Contract #: 04-0120F4Cty: SF/ALA Rte: 80 PM: 13.2/13.9File #: 69.25B**QUALITY ASSURANCE -- NON-CONFORMANCE REPORT****Location:** Changxing Island, Shanghai, P.R. China**Report No:** NCR-000726**Prime Contractor:** American Bridge/Fluor Enterprises, a JV**Date:** 01-May-2010**Submitting Contractor:** Zhenhua Port Machinery Company, Ltd (ZPMC), Changxing Island**NCR #:** ZPMC-0689**Type of problem:**

Reference Description: Excessive heat was utilized during heat straightening of the traveler rail bracket TR6A-052; QC allowed heat straightening to be performed without a temperature measuring device

Job Name: SAS Superstructure

Subject: NCR No. ZPMC-0689

Reference Description: Excessive heat was utilized during heat straightening of the traveler rail bracket TR6A-052; QC allowed heat straightening to be performed without a temperature measuring device

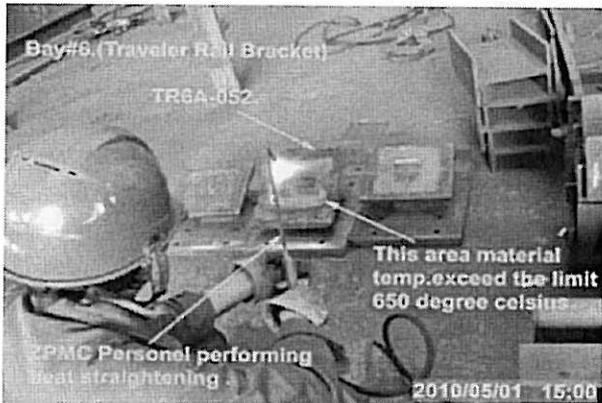
During the Quality Assurance (QA) random in-process observations of the fabrication of OBG Traveler Rail (TR) brackets, this Caltrans QA Inspector observed the following:

- ZPMC personnel perform heat straightening of traveler rail bracket base plate. The material was heated to a bright red color.
- Per ZPMC Heat Straightening Report identified as HSR1 (B)-8405, the maximum temperature is 650 °C.
- AWS D1.5 2002 defines the color of material heated to 650 °C as a "dull red color".
- A temperature indicating crayon, digital temperature measurement gauge, or other similar means of monitoring the temperature was not utilized by ZPMC QC and the actual maximum attained temperature was not measured.
- ZPMC QC personnel Shen Jian Gao was aware of the on-going heat straightening work performed without any temperature measuring device.
- The Traveler Rail Bracket is identified as TR6A-052.
- The base material thickness measured 30mm.

AWS 1.5 2002 section 3.7.3 "Members distorted by welding shall be straightened by mechanical means or by carefully supervised application of a limited amount of localized heat as approved by the Engineer. The temperature of the heated areas as measured by approved methods shall not exceed 600°C [1100°F] for quenched and tempered steel nor 650°C [1200°F] (a dull, red color) for other steels. The part to be heated for straightening shall be substantially free of stress and from external forces, except those stresses resulting from the mechanical straightening method used in conjunction with the application of heat."

Hardness testing 10TR3-002

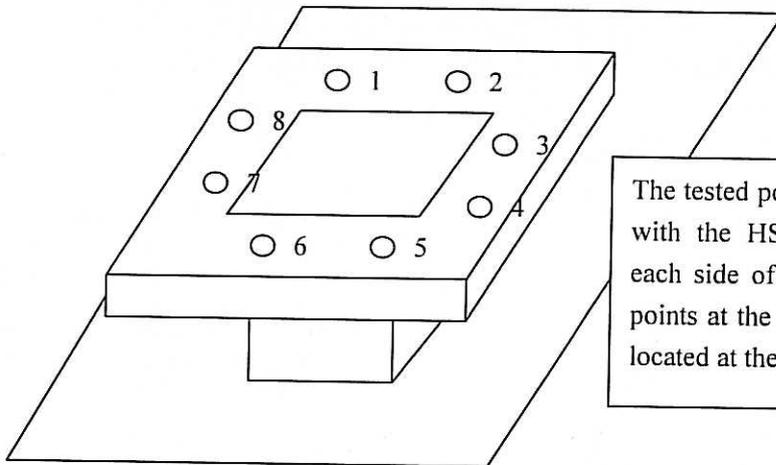
Provide hardness scale unit for the tested value. (i.e., HV = Vickers Hardness, HB = Brinell Hardness)

Data shall include tested areas that were heated excessively along with control areas for comparison.

ZPMC stated that "after review with ASTM A709 & ASTM A370 what regarding the hardness & tensile requirement, these hardness values were found to be acceptable." Provide analysis to demonstrate how this conclusion is made. (i.e., comparing the actual MTR from the mill) Provide documentation for the Engineer to evaluate acceptance in accordance with the contract requirements.

The tested points were located along with the HS trace. Two points at each side of the square. The tested points at the compared bracket were located at the similar locations.

Flange			
HS Area (TR6A-PP52)		No HS Area (TR6A-PP108)	
Location	Data	Location	Data
1	152	1	185
2	156	2	179
3	165	3	194
4	160	4	176
5	152	5	143
6	156	6	165
7	181	7	195
8	152	8	195

Joint fit-up Coating Other Component: Traveler Rail 11TR2-007

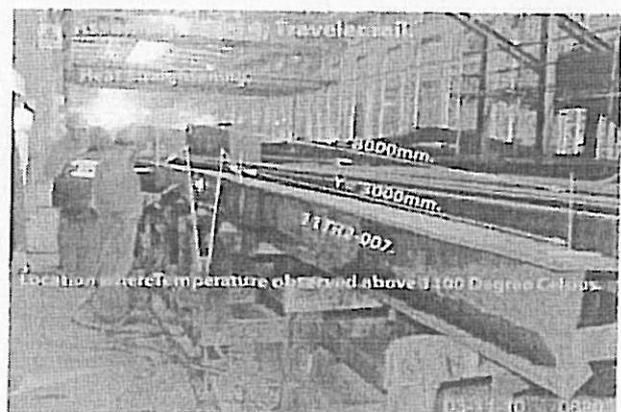
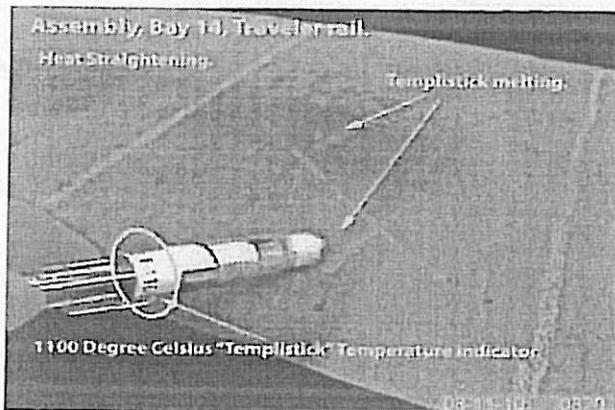
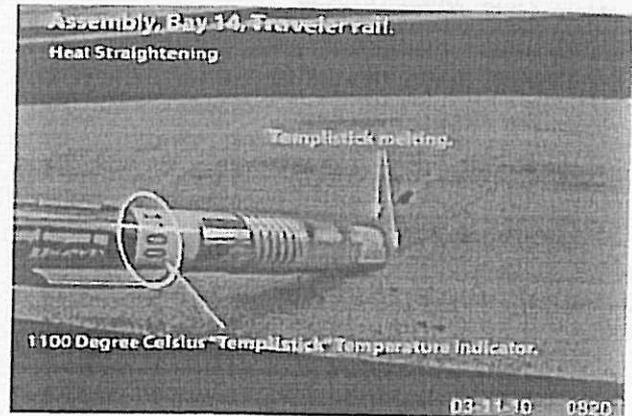
During the Quality Assurance (QA) random in-process visual inspection of OBG traveler rail Heat Straightening, this QA Inspector observed the following:

- Temperature of the heat straightened traveler rail was beyond the allowable 650 Degree Celsius in two locations.
- Per ZPMC heat straightening report (HSR) maximum temperature limit is 650 Degree Celsius.
- The 1100 Degree Celsius rating "templstick" was melted when check was made against the metal surface.
- "Y" location of the spots identified as 3000mm & 8000mm at the flange.
- The Traveler Rail is identified as 11TR2-007.

AWS 1.5 WORKMANSHIP, 3.7.3 "Members distorted by welding shall be straightened by mechanical means or by carefully supervised application of a limited amount of localized heat as approved by the Engineer. The temperature of the heated areas as measured by approved methods shall not exceed 600°C [1100°F] for quenched and tempered steel nor 650°C [1200°F] (a dull, red color) for other steels. The part to be heated for straightening shall be substantially free of stress and from external forces, except those stresses resulting from the mechanical straightening method used in conjunction with the application of heat."

Reference Description: Excessive heat was utilized during heat straightening of the traveler rail 10TR3-022

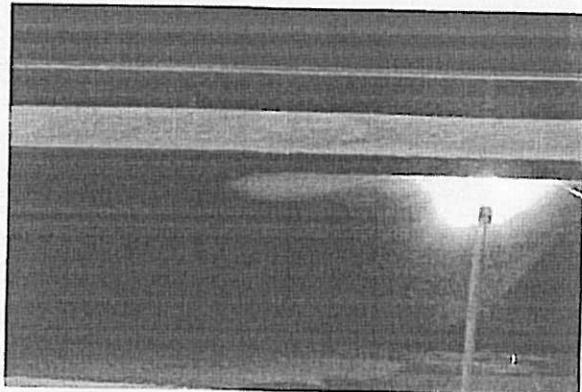
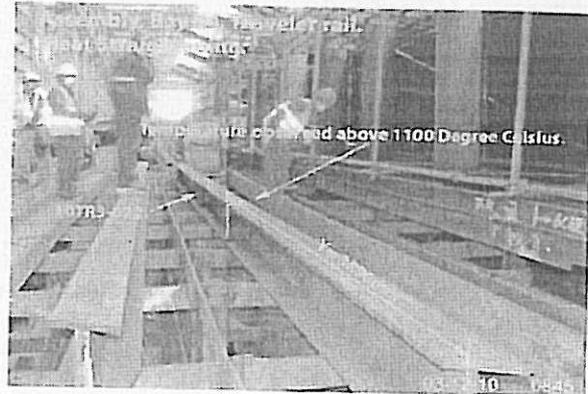
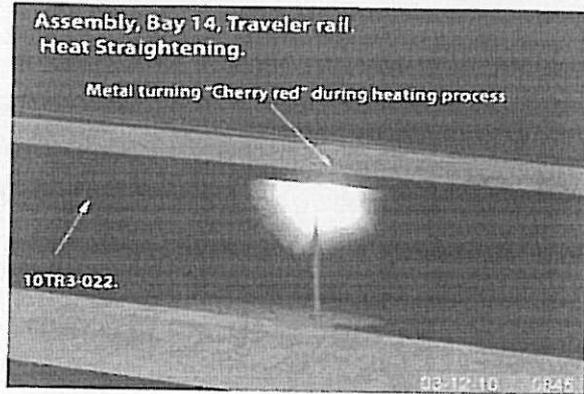
During the Quality Assurance (QA) random in-process visual inspection of OBG traveler rail Heat Straightening, this QA Inspector observed the following:

- Temperature of the heat straightened traveler rail was beyond the allowable 650 Degree Celsius.
- Metal color turns into "cherry red" after it was heat straightened.
- Per ZPMC heat straightening report (HSR) maximum temperature limit is 650 Degree Celsius.
- The 1100 Degree Celsius rating "templstick" was melted when check was made against the metal surface.
- "Y" location of the spot identified was 3890 mm and it is at the flange to web joint.
- The Traveler Rail is identified as 10TR3-022.

AWS 1.5 WORKMANSHIP, 3.7.3 "Members distorted by welding shall be straightened by mechanical means or by carefully supervised application of a limited amount of localized heat as approved by the Engineer. The temperature of the heated areas as measured by approved methods shall not exceed 600°C [1100°F] for quenched and tempered steel nor 650°C [1200°F] (a dull, red color) for other steels. The part to be heated for straightening shall be substantially free of stress and from external forces, except those stresses resulting from the mechanical straightening method used in conjunction with the application of heat."

Reference Description: Heat straightening utilizing excessive heat and performing the work with no written procedure to show QA and QC on Floorbeam FB3014-001

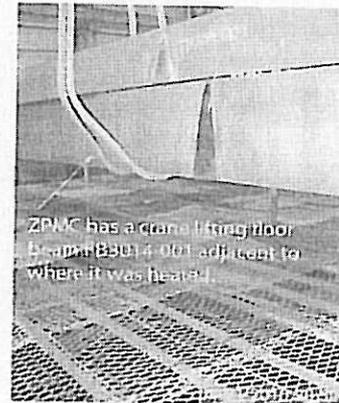
During random in process observations of OBG segment 12CE in Bay 14, this Caltrans Quality Assurance (QA) Inspector observed the following issues:

- Heat straightening was performed on Floorbeam FB3014-001 without an approved heat straightening document.
- ZPMC had a crane lifting upward with an unknown amount of uplifting force on the Floorbeam while heat straightening the Floorbeam base metal to a bright cherry-red color.

- The AWS D1.5 Section 3.7.3 states that the heated steel shall not exceed 650°C, which gives a dull red color.
- ZPMC QC Certified Welding Inspector (CWI) Geng Wei and the ABF representative Yang Chao were not aware that this heat straightening was taking place.

- ZPMC CWI did not know if a heat straightening document had been submitted for this activity, and no document was issued to record this activity had taken place.

- A temp stick, digital temperature measurement gauge, or other similar means of monitoring the heat input was not utilized by ZPMC personnel and the actual maximum attained temperature was not measured.

- Floorbeam FB3014-001 is welded in place at OBG segment 12CE near panel point PP115.5.

Reference Description: Excessive heat was utilized during heat straightening of the traveler rail 10TR3-022

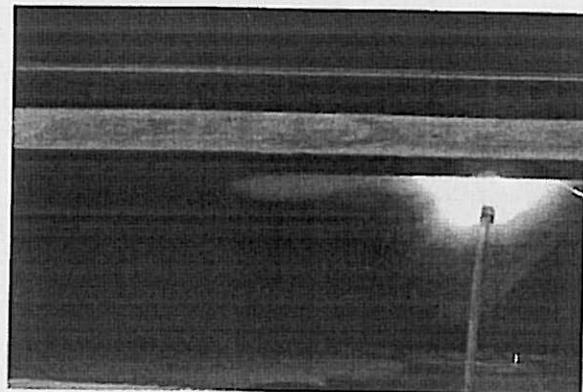
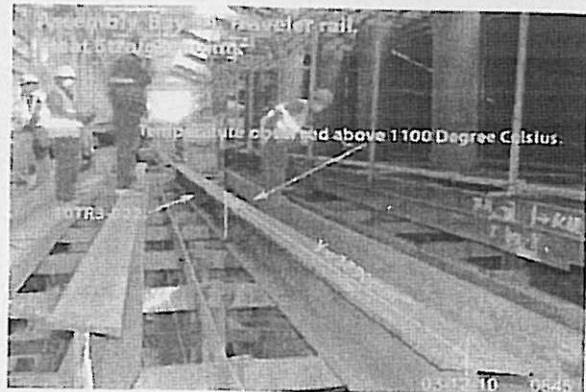
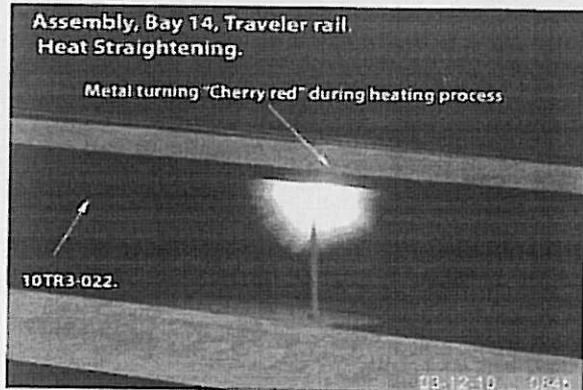
- Temperature of the heat straightened traveler rail was beyond the allowable 650 Degree Celsius.
- Metal color turns into "cherry red" after it was heat straightened.
- Per ZPMC heat straightening report (HSR) maximum temperature limit is 650 Degree Celsius.
- The 1100 Degree Celsius rating "templstick" was melted when check was made against the metal surface.
- "Y" location of the spot identified was 3890 mm and it is at the flange to web joint.
- The Traveler Rail is identified as 10TR3-022.

Reference Description: Excessive heat was utilized during heat straightening of the traveler rail bracket TR6A-052; QC allowed heat straightening to be performed without a temperature measuring device

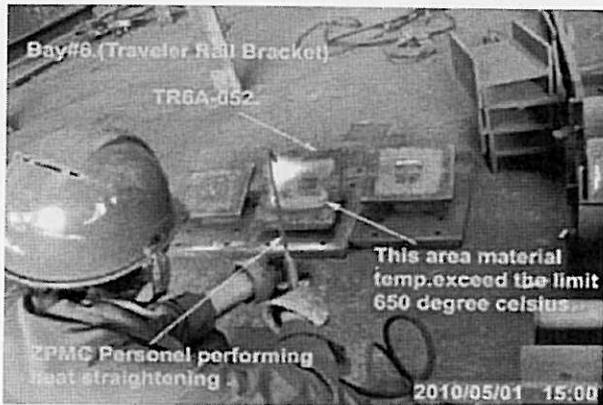
During the Quality Assurance (QA) random in-process observations of the fabrication of OBG Traveler Rail (TR) brackets, this Caltrans QA Inspector observed the following:

Perform hardness testing over area in question.

Contractor submitted results of hardness testing performed on the area in question. After review, the Department has found the results to be acceptable. ZPMC also issued an internal NCR in regards to this issue.
